Application for Licence Amendment

Licence Number	L9155/2018/1
Licence Holder	Avoca Mining Pty Ltd
ACN	108 547 217
File Number	DER2018/001153
Premises	Higginsville Gold Project HIGGINSVILLE, WA, 6443 Mining Tenements M15/351, M15/289, M15/225, M15/642, M15/348, M15/31, M15/786, M15/506, M15/507, M15/620, M15/629, M15/639, M15/640, M15/580, M15/581, M15/597, L15/225, L15/288, L15/302, G15/19, G15/23, M15/528, M15/231, M15/748, M15/512, M15/352, M15/610, M15/375, M15/338, M15/1790, M15/1814, L15/282, L15/347, G15/26, G15/27, G15/29, L15/382, L15/389, M15/325, M15/681, M15/817 and L15/298.
Date of Report	22 September 2023
Decision	Revised licence granted

Figure 1: Layout of Pioneer open pit operation

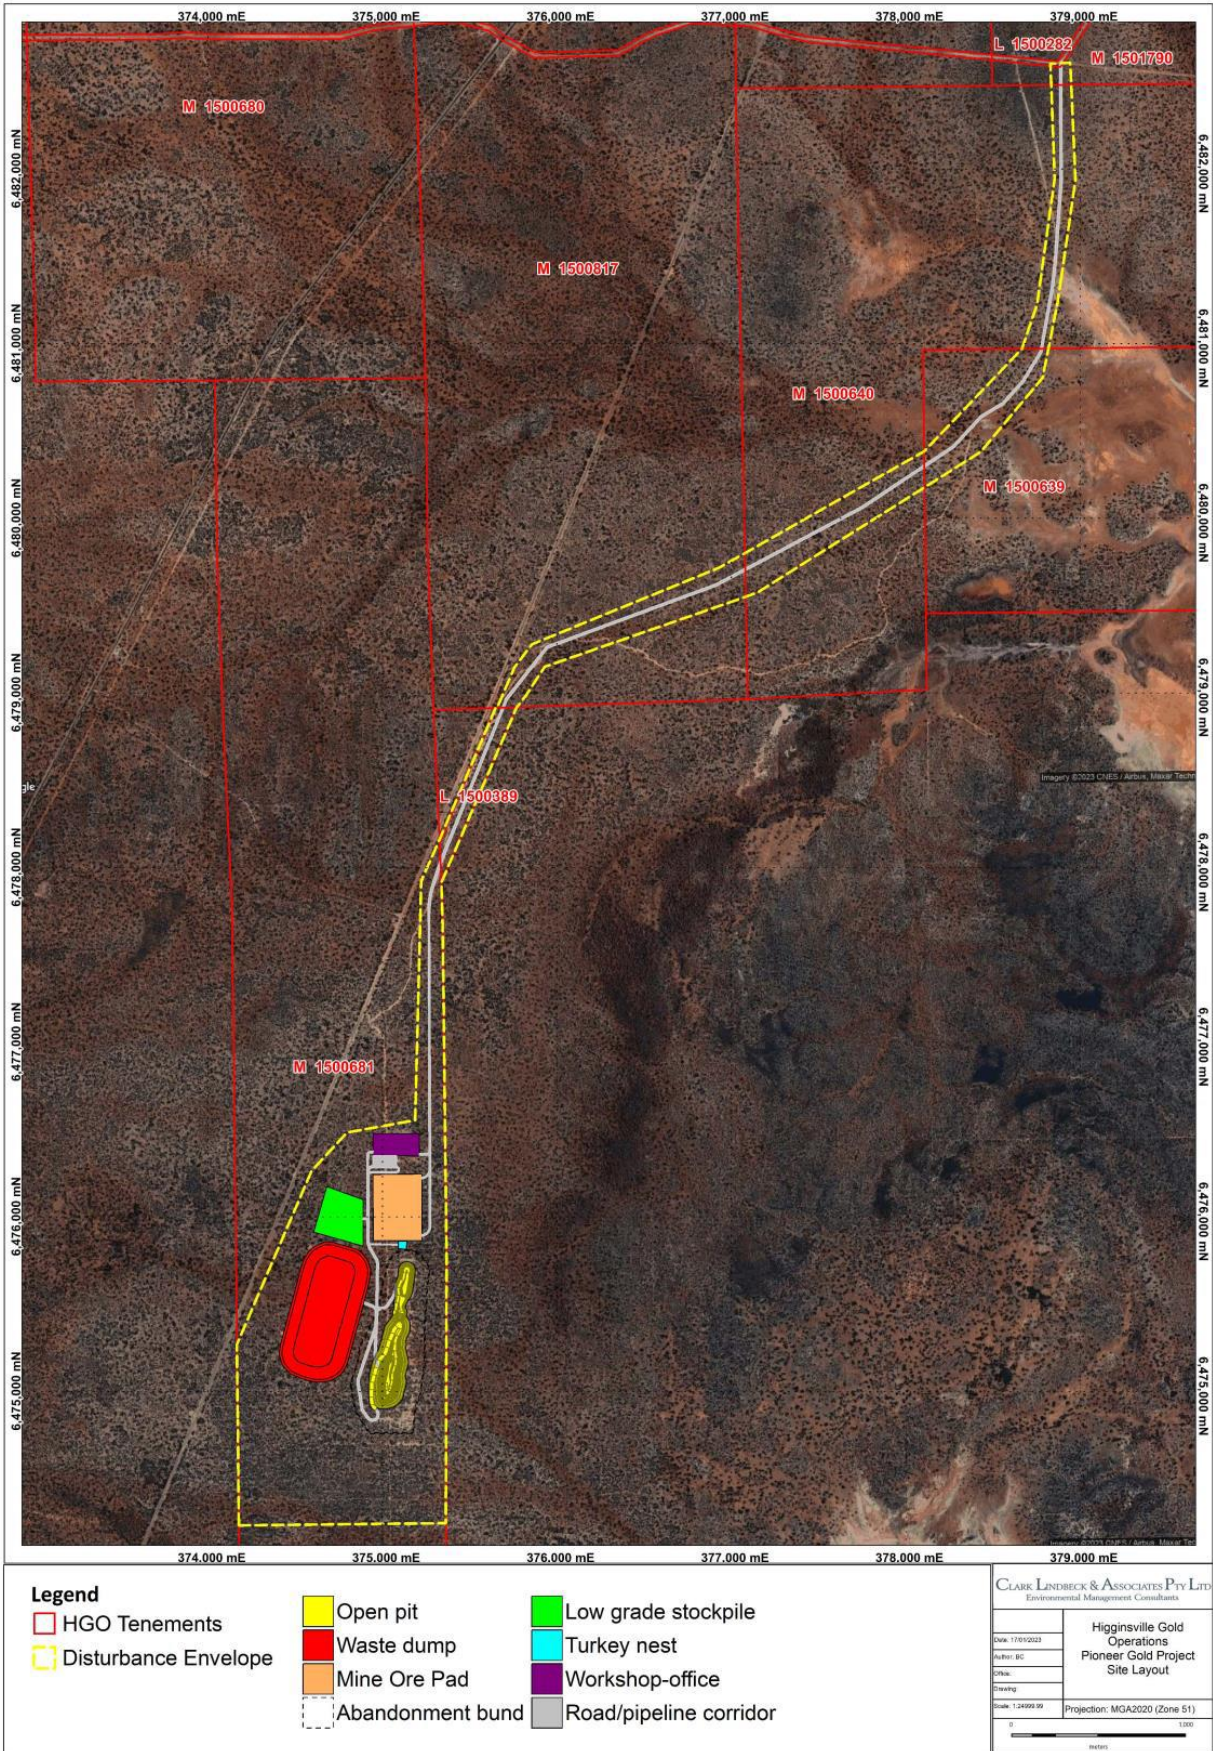
The licence holder is seeking to create a new open pit mine within the premises boundary, the Pioneer open pit (refer to Figure 1). The applicant is requesting to construct new dewatering infrastructure for this pit, including pipelines, earthen bunding, and an 80m by 80m, HDPE-lined turkey's nest to contain the mine water. The turkey's nest will be located adjacent to the new pit. Excess mine water will be transferred about 10kms north to the Aphrodite East pit (an existing dewatering discharge point authorised on the licence), which is then used as a source of water for the processing plant.

In comparison, the groundwater samples from the Pioneer open pit area have returned TDS measurements of around 42,000mg/L (comparable to the groundwater around the Aphrodite East pit) with a pH of about 3.5 (acidic).

Figure 2: Layout of Chalice borefield and pit

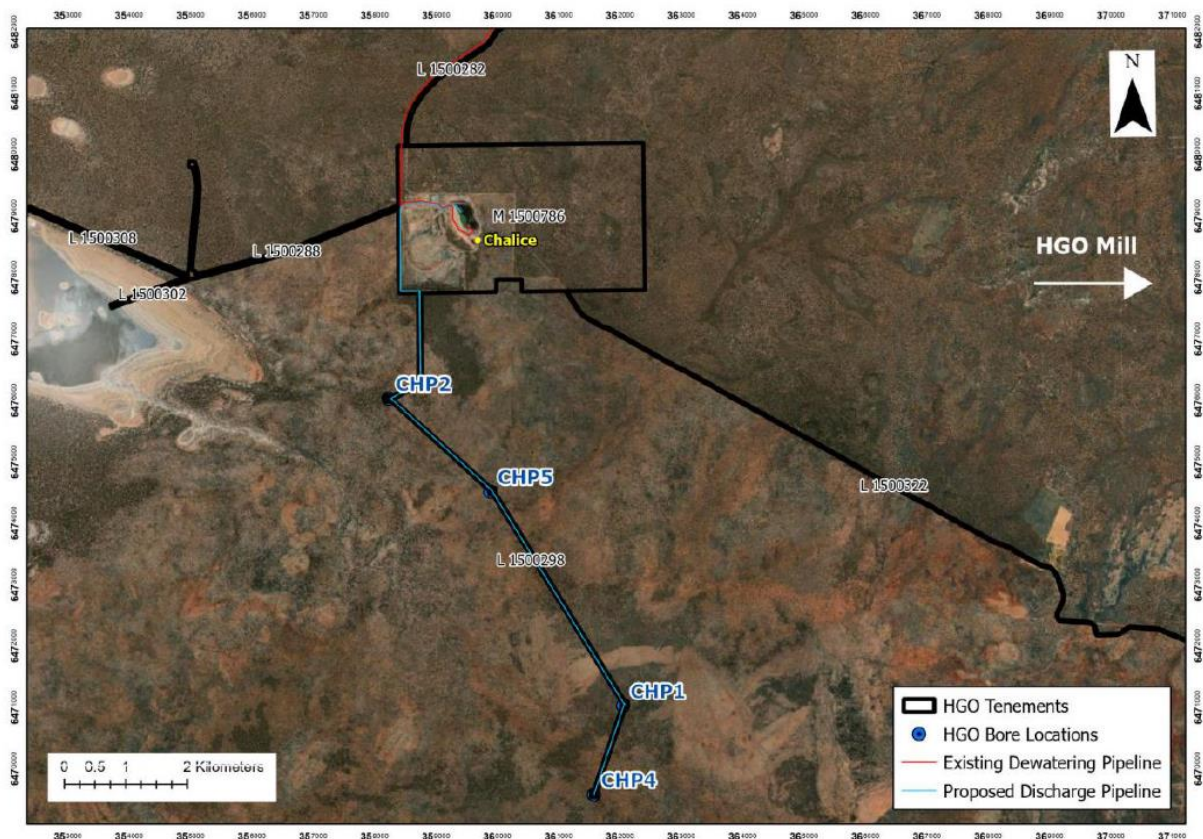
The licence holder also plans to recommission four production bores from the Chalice borefield to the south of the Chalice open pit (refer to Figure 2). The bores will be constructed/recommissioned in accordance with CAW207251(1) – Licence to Construct or Alter a Well, which has already been granted under the *Rights in Water and Irrigation Act, 1914* (RIWI Act).

The amendment to the premises licence will concern the construction of an 80m by 80m, HDPE-lined turkey’s nest adjacent to the pit, the construction of the pipeline and earthen bunding from the borefield to the turkey’s nest, and the discharge of borefield water to the turkey’s nest or the Aphrodite East pit.

Samples taken from the Chalice borefield show that the salinity ranges between 46,000 and 136,000mg/L TDS, and the pH is between 3 and 4 (acidic). This is materially different from the water that is currently being drawn from the Chalice open pit. The pH of the water in the Chalice pit is neutral at 6 to 8, and has a salinity of about 200,000mg/L. Under the current licence, water from the Chalice open pit is authorised to be discharged to Aphrodite East pit, Poseidon North pit or discharged to the salt lake, Chalice West Lake.

As the licence holder does not currently have studies showing how the chemistry of the borefield water could impact potential surface water bodies (such as Chalice West Lake), they intend to only deposit this water in the HDPE-lined turkey's nest adjacent to Chalice pit or to the Aphrodite East pit (which does not discharge to any surface water bodies), before being transferred to the processing plant.
